Serial No.: 10/130,752  
Amendment dated 11/08/05  
Reply to Office Action of 08/10/05

### **Amendments to the Figures**

Fig. 5 A

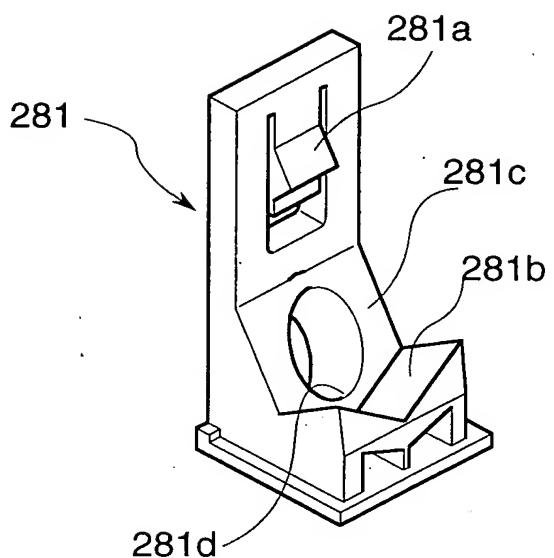
Please replace Fig. 5 with the amended Replacement Fig. 5 attached in the Appendix. Fig. 5 has been amended to reflect the changes required by the Examiner. An annotated sheet of Fig. 5 showing the corrections marked in red is attached hereto.

In regard to the drawings, the position of the nut retainer 283 is shown in the drawings. It is the item that holds the top and front parts of nut 282 in place. Nut holder 281 holds the bottom and back parts of the nut 282 in place. Nut retaining apparatus N refers to the combination of the nut retainer and nut holder. The disclosure describes these elements of the drawings. Withdrawal of the objections over the drawings and disclosure is requested.

FIG 5 has been corrected (attached) and a new abstract has been added.
